FS47-24

IBC: 714.5, 714.5.1

2024 International Building Code

714.5.1 Through penetrations.

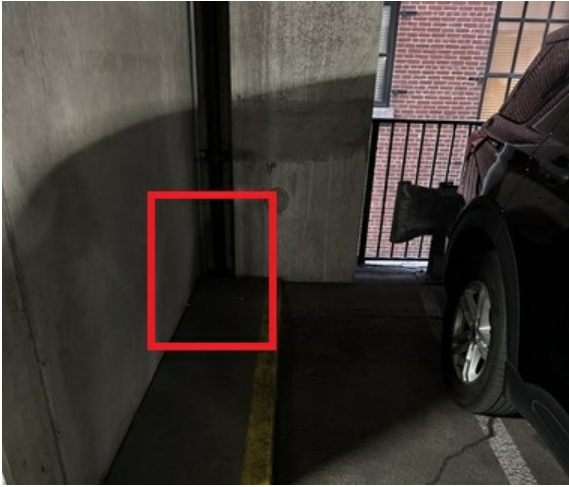
The photos below show an example of a parking garage penetration. These photos were taken at the Marriott St Louis Grand Hotel multi-story parking garage. An approximate 12 in. by 12 in. opening was located approximately 4 ft from an adjacent parked car. By the 2024 IBC, this unprotected opening is permitted. Is the level of protection we should be permitting?

4. ~~Penetrations of concrete floors or ramps within parking garages or structures constructed in accordance with Sections 406.5 and 406.6 where the areas above and below the penetrations are parking areas.~~ Vehicle ramps within or adjacent to parking garages or structures constructed in accordance with Sections 406.5 and 406.6 that are not used for vehicle parking do not require penetrations to comply with Section 714.5.1.1, 714.5.1.2 or 714.5.1.3.
